# Access Compliance Report

### (Curb Ramps)

Intersection ID: 52102	Main Street: TANK_FARM_RD	Cross Street: FRED_D_ALEXANDER_BV	Location: S
ADA ID: DAD3F9A6FD3B	Ramp Type: Perp	Initial Pass/Fail: Fail	Overall Compliance: No
			Severity Score: 1.25

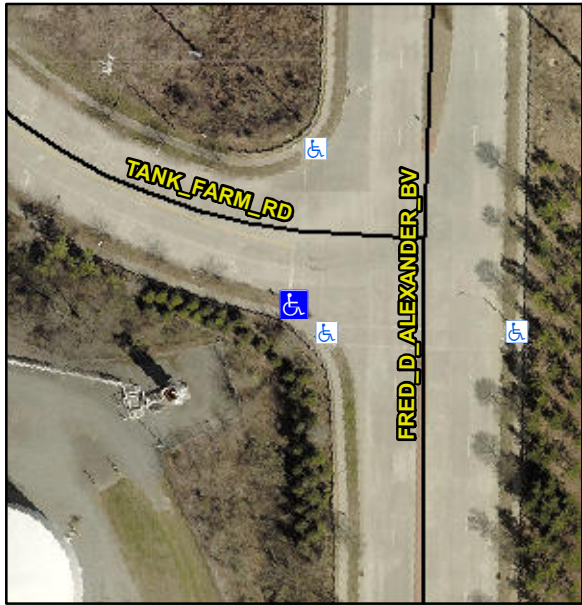
Codes/Mitigation Info/Possible Solution			Field Measurements/Component Compliance					
	Possible Solutions:		Compliance	Description	Data	Compliance	Description	Data
	Remove & Replace Entire Ramp.		N/A	Ramp Length (in)	124.0	Yes	Ramp Slope (%)	7.0
			Yes	Ramp Width (in)	48.0	No	Ramp XSlope (%)	4.7
			N/A	Flare Type LT	N/A	N/A	Flare Type RT	N/A
			N/A	Flare Slope LT (%)	N/A	N/A	Flare Slope RT (%)	N/A
			N/A	Flare Traversable LT?	N/A	N/A	Flare Traversable RT?	N/A
			N/A	Landing Length (in)	N/A	N/A	DWS Provided?	N/A
			N/A	Landing Width (in)	N/A	N/A	DWS Contrast?	N/A
			N/A	Landing Slope (%)	N/A	N/A	DWS Length (in)	N/A
			N/A	Landing X Slope (%)	N/A	N/A	DWS Full Width?	N/A
Surveyor Notes:		N/A	N/A	Landing Curb? (Y/N)	N/A	N/A	DWS Offset (in)	N/A
PROW/ADA:		Not Found, R304.5.3	N/A	Shared Landing?	N/A	N/A	Gutter Slope (%)	N/A
			N/A	Gutter Ponding?	N/A	N/A	Gutter X Slope (%)	N/A
			N/A	Gutter Lip Ht (in)	N/A	N/A	Painted X Walk2?	N/A
